Issue List

- 1 INCORRECT GRILLE - KITCHEN
- CONDENSER DRAIN IN THE WAY OF DOOR
- EF1 NO SPEED CONTROLLER
- INACCESSIBLE DAMPER

02-09-26 QT #0489 CASA GRANDE, AZ

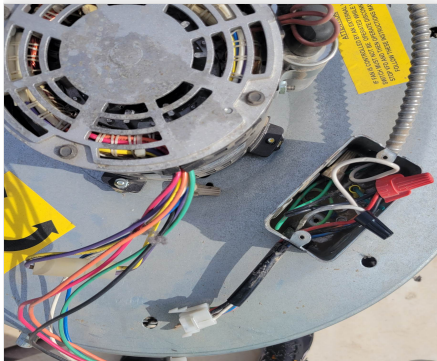
Issue Name : CONDENSER DRAIN IN THE WAY OF DOOR
Description : The door to the mixed air compartment cannot be opened very far, due to the drain being in the way. The economizer control could barely be reached. Recommend cutting the pipe down, it doesn't need to be that tall anyway.
Created By : National TAB **Assigned To :** National TAB - Dan Hertenstein
Status : Open
Priority : Low **Asset Tag :** RT-3
Originated Date : 02/13/2026 - Christine Weale - National TAB

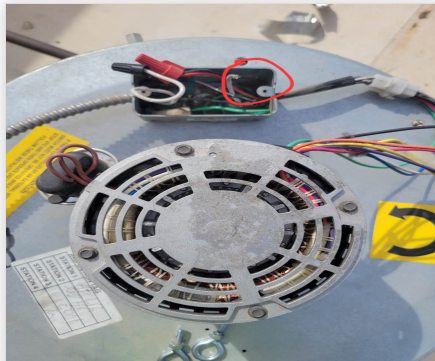
Issue Name : EF1 NO SPEED CONTROLLER
Description : When I arrived, EF1 was improperly wired and not running, I fixed it, but it was running way too high so I disconnected the fan for safety. There should be a safety disconnect switch and a speed control. There isn't, so it's unplugged at the motor connector.
Created By : National TAB **Assigned To :** National TAB - Dan Hertenstein
Status : Open
Priority : Urgent **Asset Tag :** EF1
Originated Date : 02/13/2026 - Christine Weale - National TAB
